TX0-LTR-0028

Subject: **Response to Request for Additional Information (Set 4) for the TRISO-X License Application**

Enclosure 1 - Geotechnical RAI Responses for the TRISO-X License Application

Attachment to Enclosure 1
 Revised License Figure 1-3: Plan View of Geologic Cross Sections

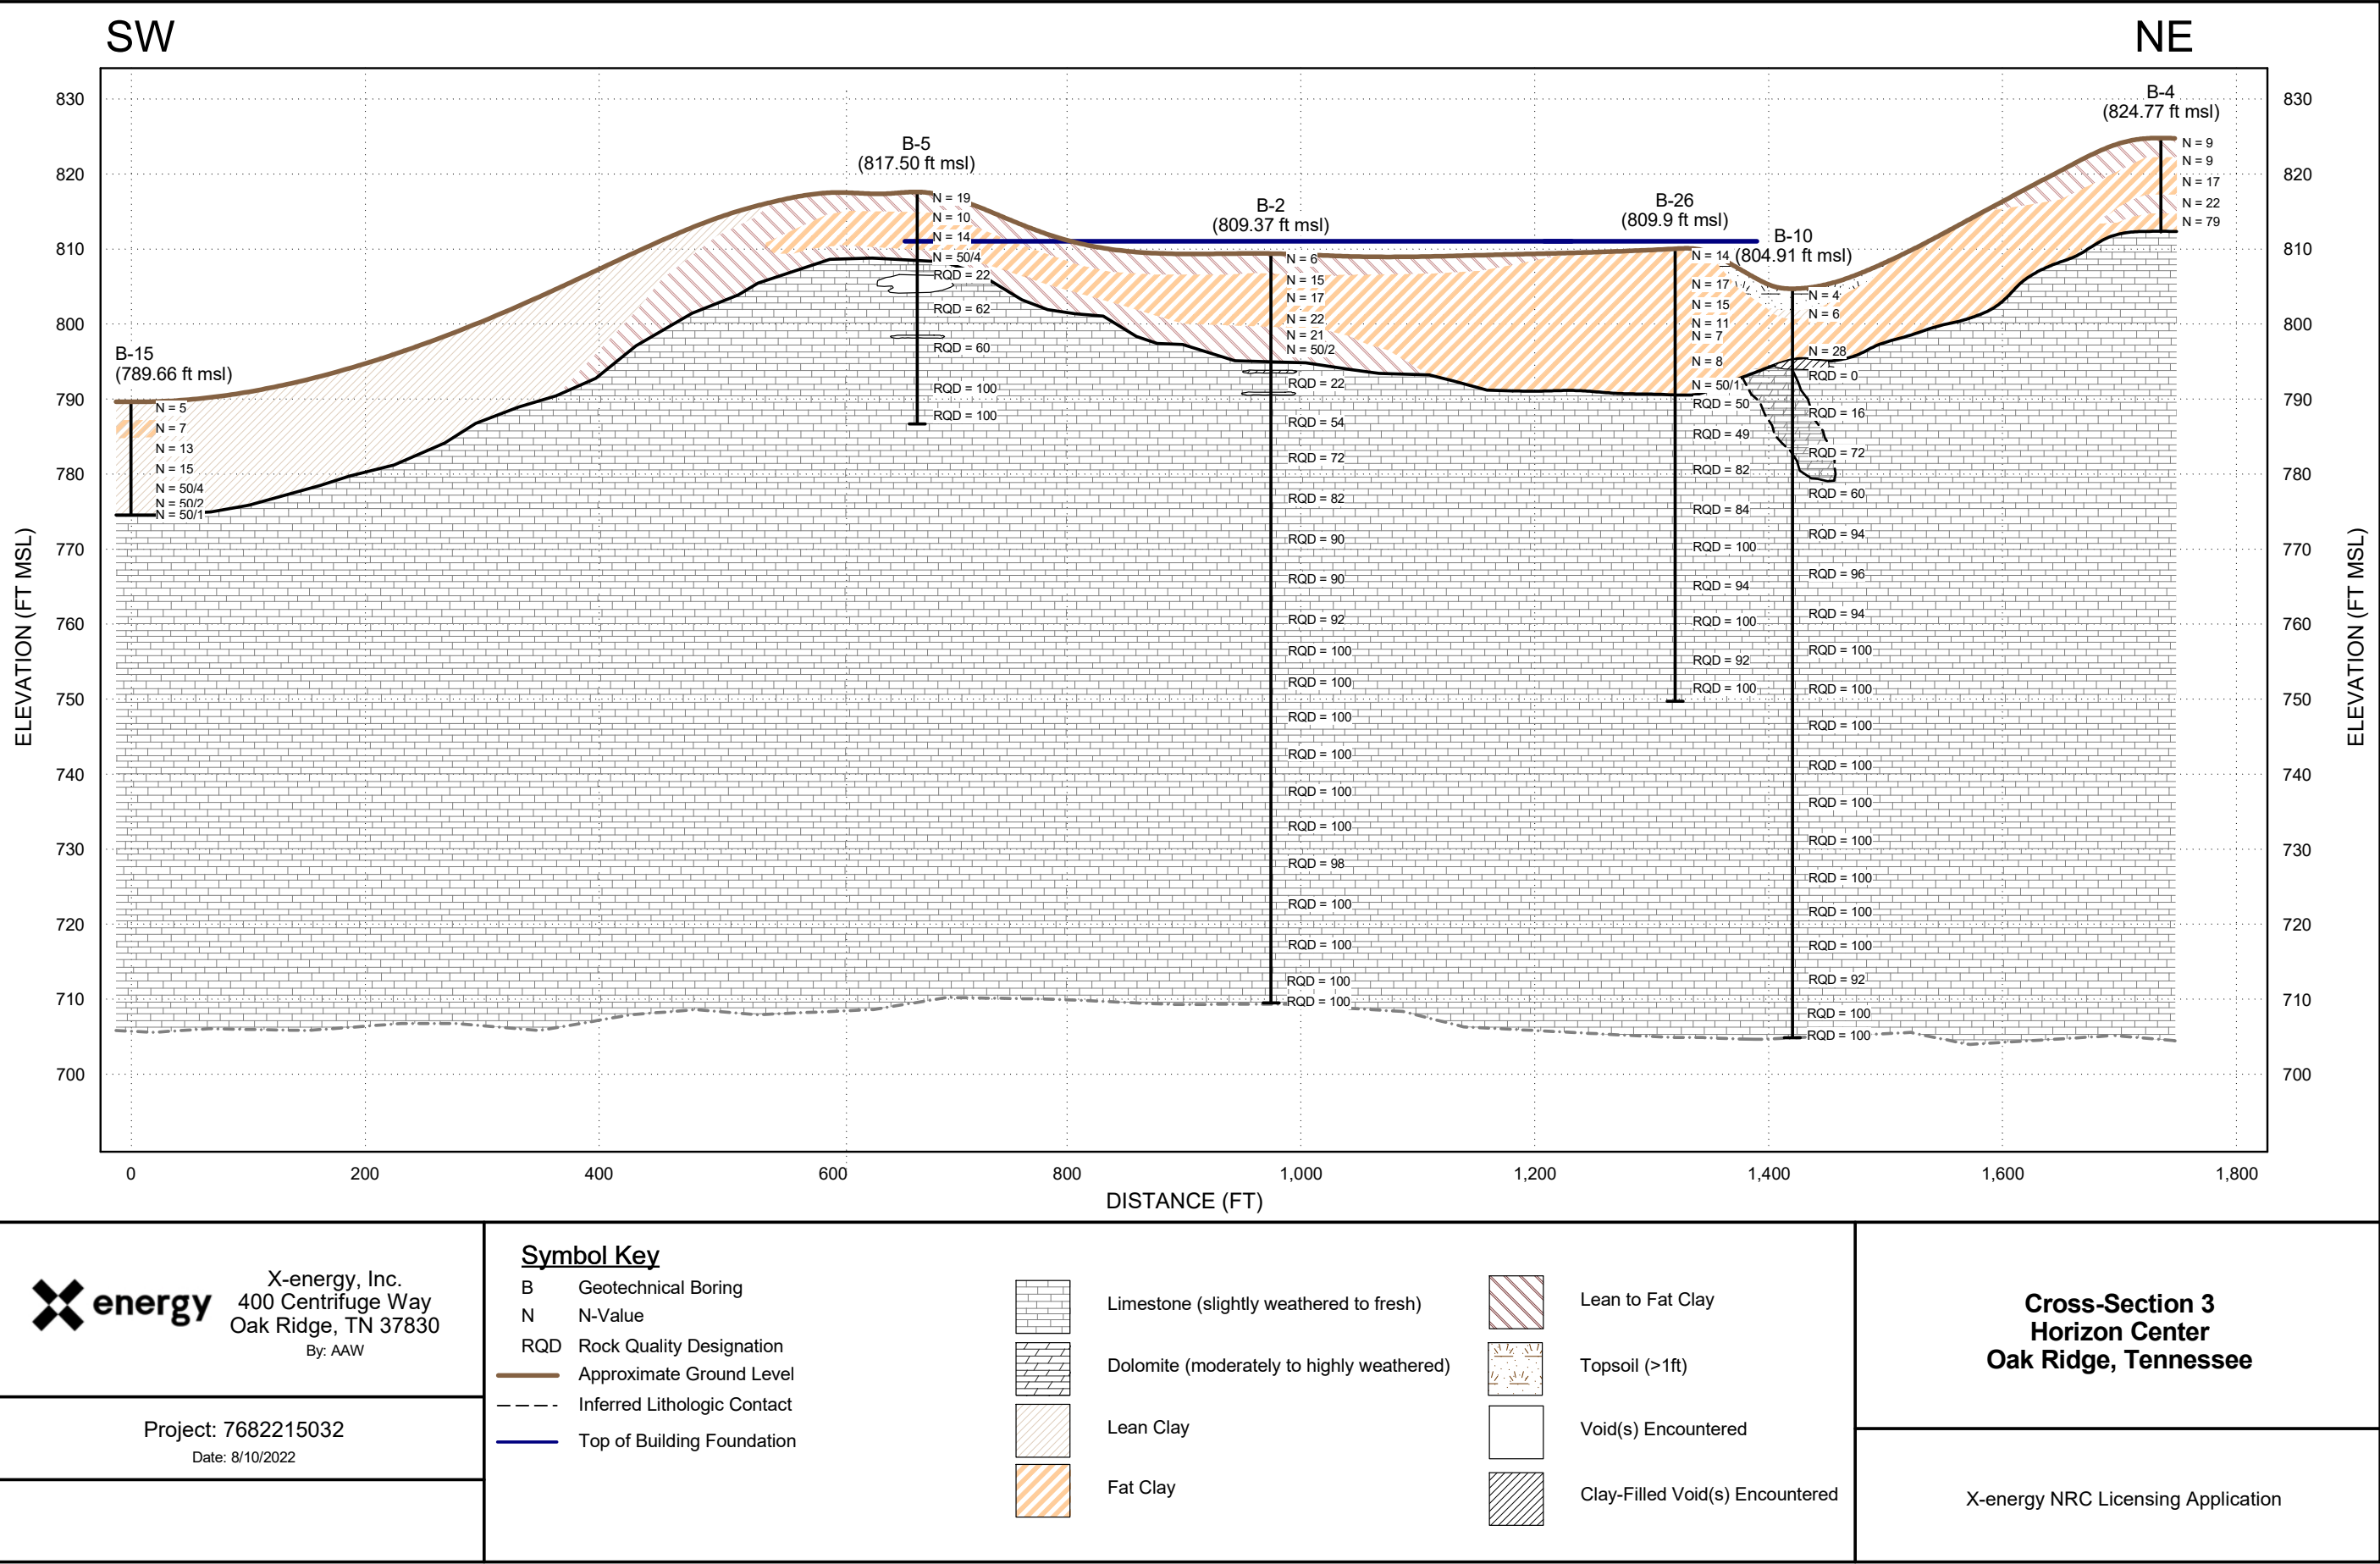
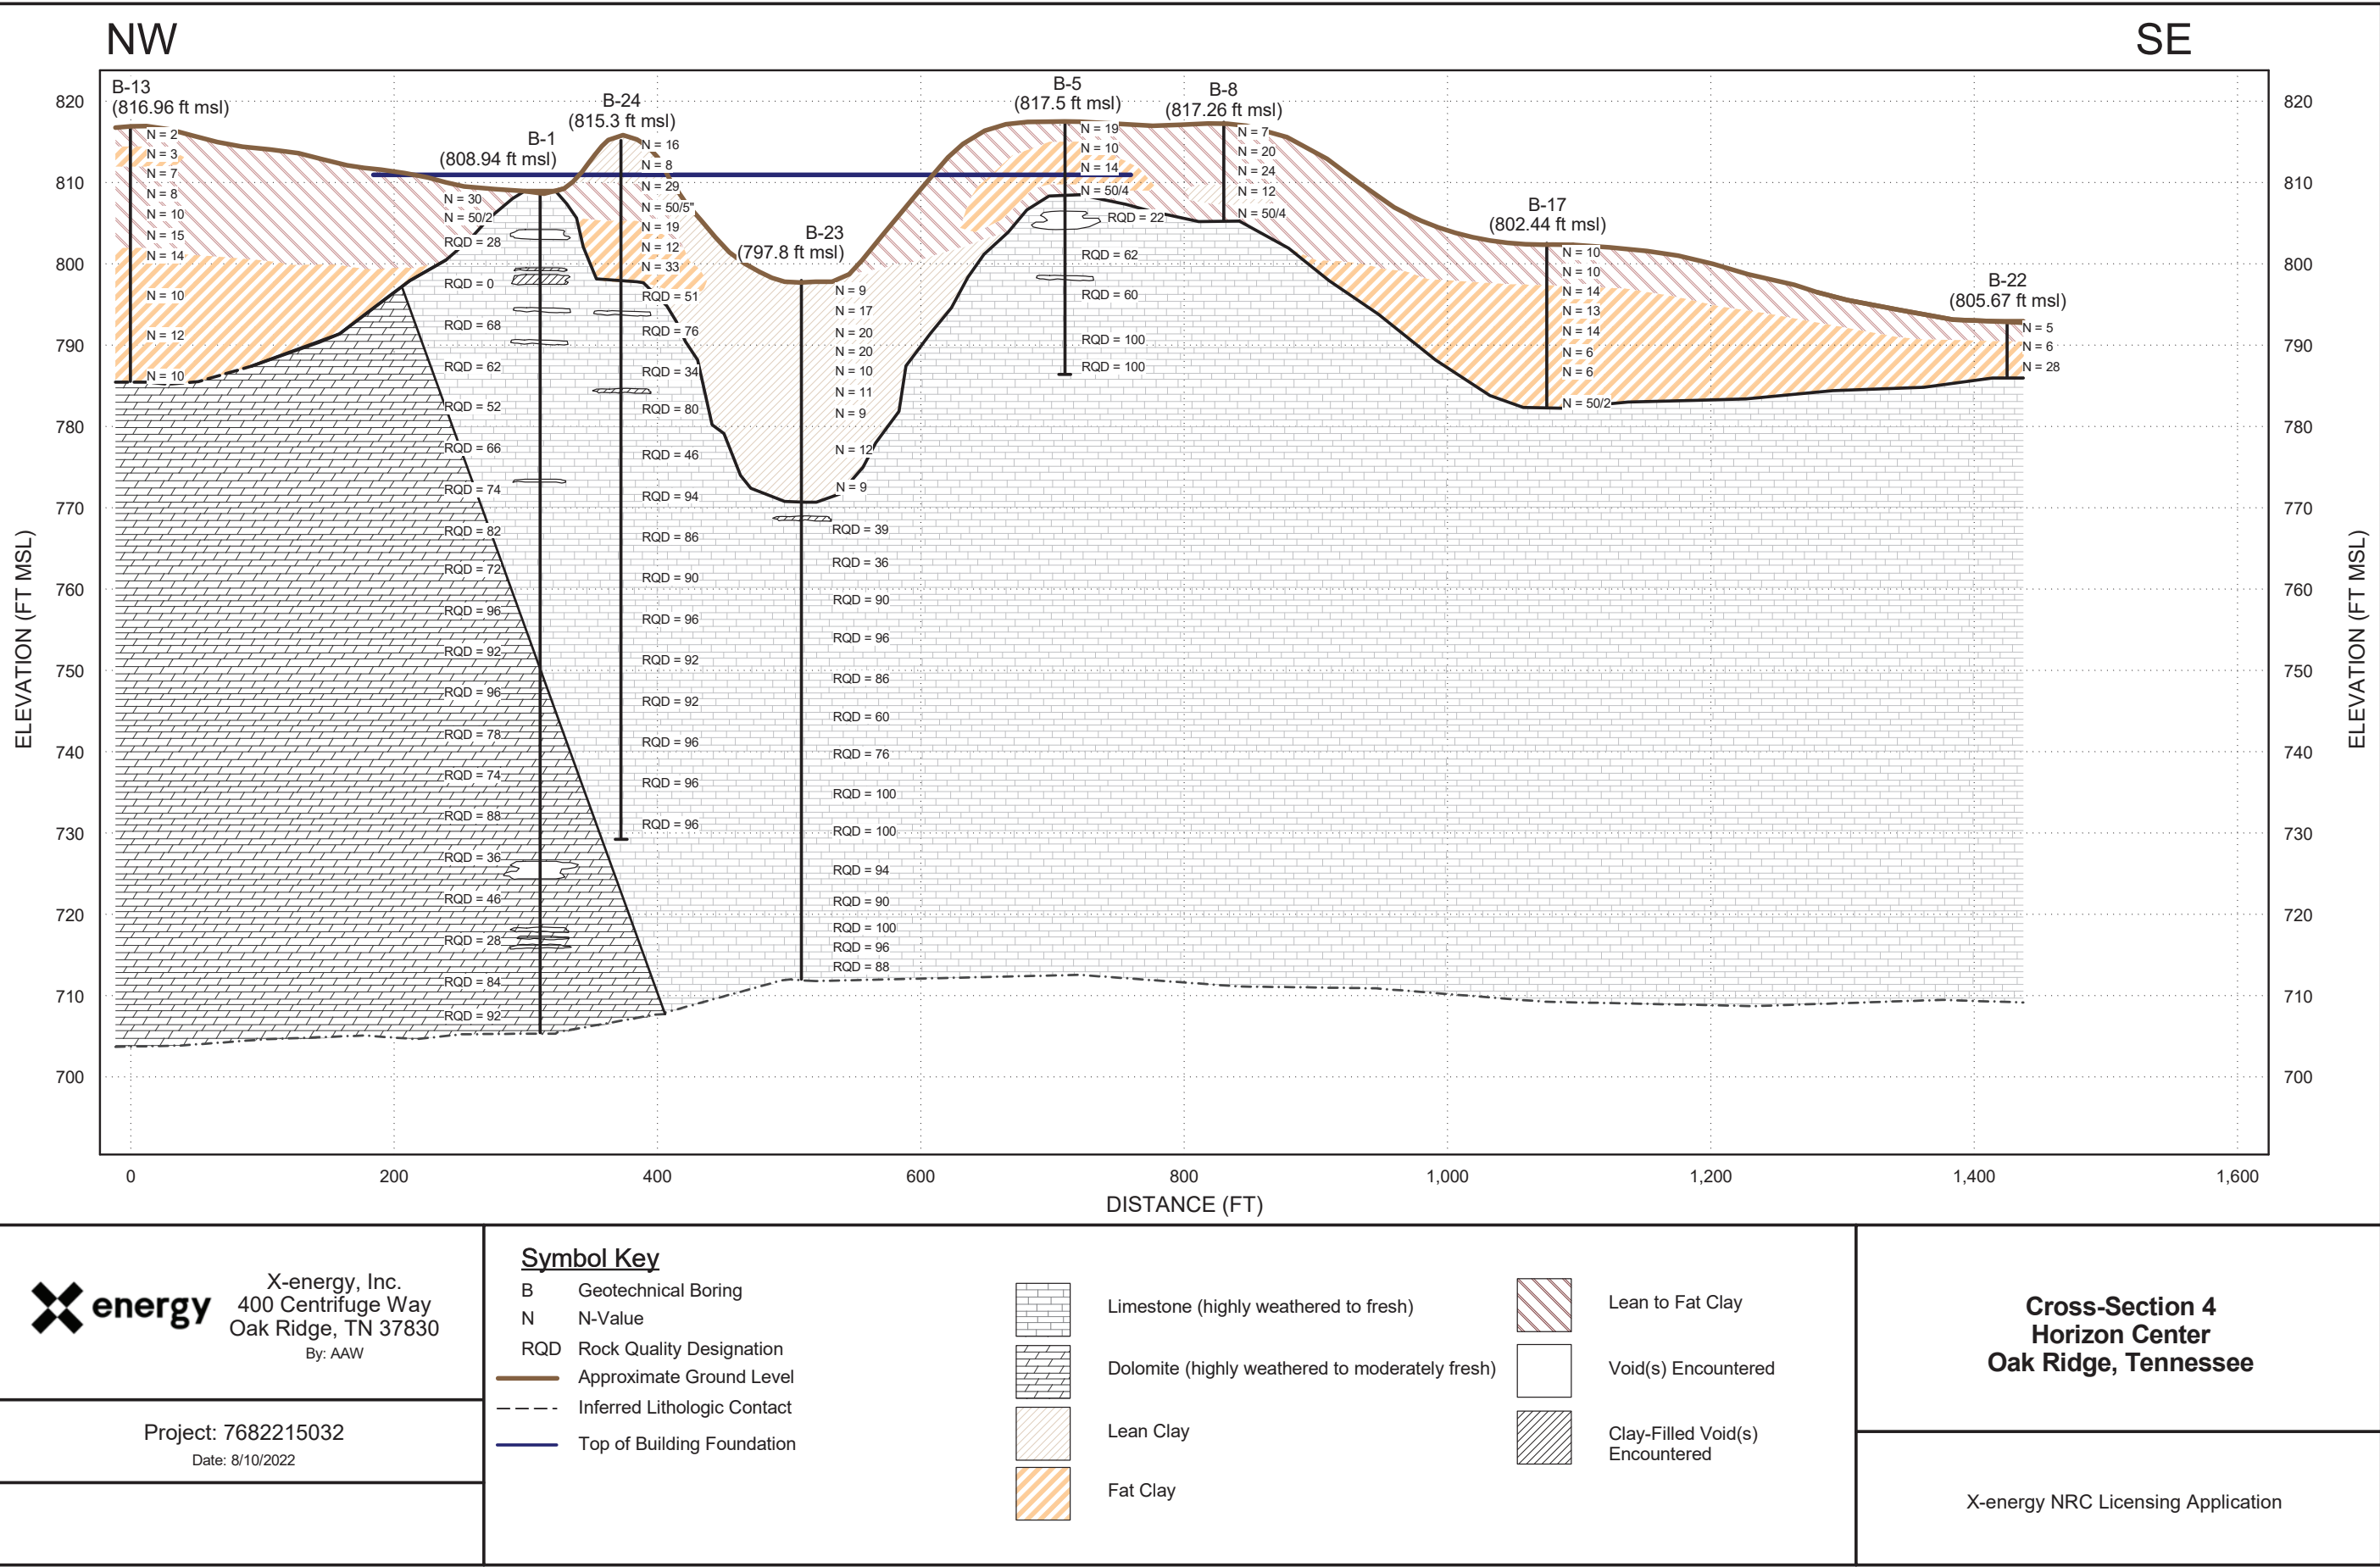
The locations of certain borings are unclear as to whether they are within or outside the footprint of the Process Building. For example, License Application (LA) Figure 1-5 (Cross Section 2) shows that Boring B-23 is outside the Process Building footprint whereas Figure 1-7 shows that B-23 is inside the footprint. In addition, the log of Boring B-3 given in Cross Section 1 (LA Figure 1-4) do not match with the log given in Cross Section 5 (LA Figure 1-8). All Rock Quality Designation (RQD) values are 54 in Cross Section 5. Additionally, the RQD values reported at deeper depths (e.g., below 720 ft elevation) of Boring B-23, shown in Cross Section 2 (LA Figure 1-5) and Cross Section 4 (LA Figure 1-7), do not match. Similarly, RQD values at deeper depths of Boring B-27 do not match in Cross Section 2 (LA Figure 1-5) and Cross Section 5 (LA Figure 1-8).

Provide an updated LA Figure 1-3 of the geotechnical boring locations superimposed on the footprint of the Process Building. Additionally, update the cross-sections provided in LA Figures 1-4 through 1-8.

License Chapter 1, Figure 1-3 (Plan View of Geologic Cross Sections) has been revised to show the boring locations superimposed on the footprint of the Process Building. Cross Sections depicted in License Chapter 1, Figures 1-4 through 1-8 have been revised to address the comments provided in RAI-1. License Chapter 1, Figure 1-7 (Cross-Section 4) depicts borings B-13 to B-22 in a two-dimensional format, viewing the cross section from the SW direction. Boring B-23, which physically does fall outside the Process Building footprint, is shown as falling within the footprint in Figure 1-7 because the cross section is viewed on a single plane, with no integration of depth.

License Chapter 1, Figures 1-3 through 1-8 will be revised as described above. Revised figures are included in the Attachment to Enclosure 1.
